Model: Aprilia Tuareg 660 E5+

Subject: Configuration for use in dusty environments

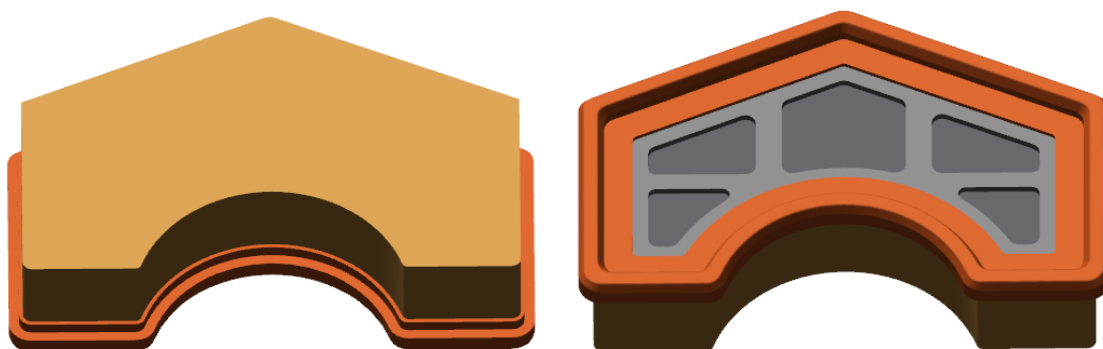
One of the primary needs in case of use even in such particularly severe conditions, is to ensure the cleanliness of the intake air by using an air filter which, if on the one hand must guarantee a good passage of air, on the other must provide filtration to prevent abrasive particles from being sucked into the cylinders generating abnormal wear and possible damage.

Under standard operating conditions, in the absence of fine dust, the standard filter, made from special high-filtration paper, is perfectly suitable and allows for the maintenance intervals specified in the use and maintenance manual. However, for the heavy duty use described above, it is necessary to use a sponge filter soaked in special filter oil, capable of stopping particularly fine particles, but which requires more frequent and careful maintenance.

The filter, code **2S002520**, available in the Aprilia accessories range, has been tested and approved by Aprilia for the Tuareg 660 / Rally E5+ model as an example of a component that meets the requirements outlined in the previous paragraph.

The use of this filter, which ensures the integrity of the engine when used in dusty and harsh environments, will be considered equivalent to the original part.

The filter code **2S002520** must undergo careful and periodic maintenance as described in the instructions accompanying each new filter.
